SUBJECT: CERTIFIED MINUTES OF THE ACRS REGULATORY  
POLICIES AND PRACTICES SUBCOMMITTEE MEETING ON  
JUNE 9, 2015

ADVISORY COMMITTEE ON REACTOR SAFEGUARDS  
MINUTES OF THE ACRS REGULATORY POLICIES AND PRACTICES SUBCOMMITTEE  
MEETING  
JUNE 9, 2015

The purpose of the meeting is to review of selected chapters, the safety evaluation report associated with the early site permit for the PSEG site. The meeting transcripts are attached and contain an accurate description of each matter discussed during the meeting. The presentation slides and handouts used during the meeting are attached to these transcripts.

### PSEG ESPA Storm Surge Screening

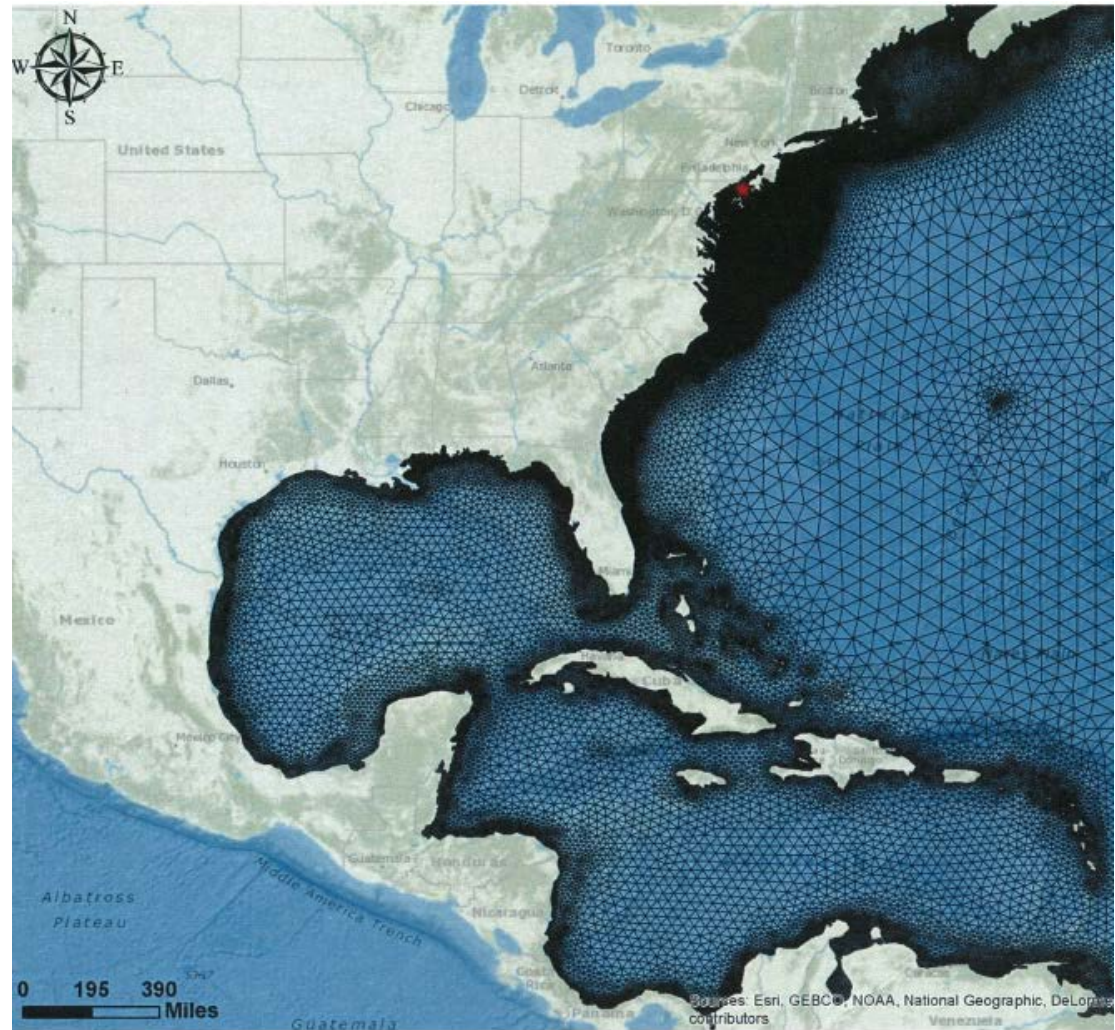
- Modeled with Bodine storm surge method
- Coupled with HEC-RAS; Kamphuis wind setup method; and Coastal Engineering Manual wave runup method
- Parameters Resulting from Screening:  $R = 28$  NM;  $T = 26$  kt
- Produces total Water Surface Elevation (WSEL) of 42.4 ft. NAVD

PSEG developed a high resolution 2-D storm surge model (ADCIRC+SWAN) to support development of the response to RAI No. 67

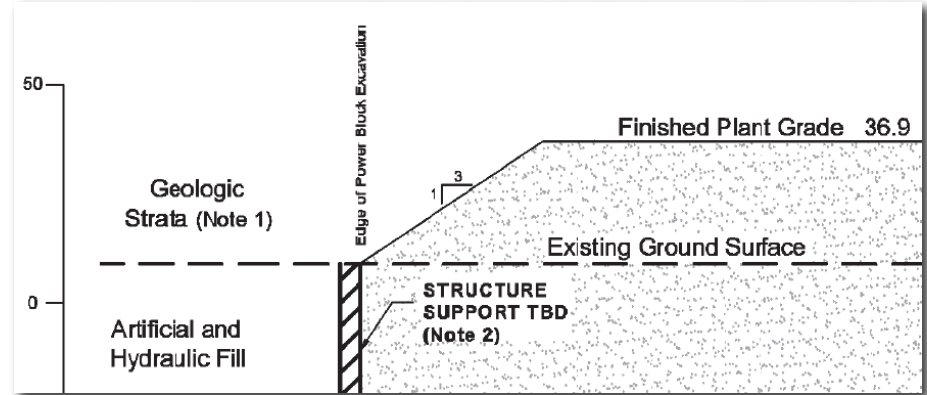
Use high resolution  
ADCIRC+SWAN  
Model to determine  
total design basis  
WSEL for the  
selected PMH storm

Finite element  
mesh refined at  
project site
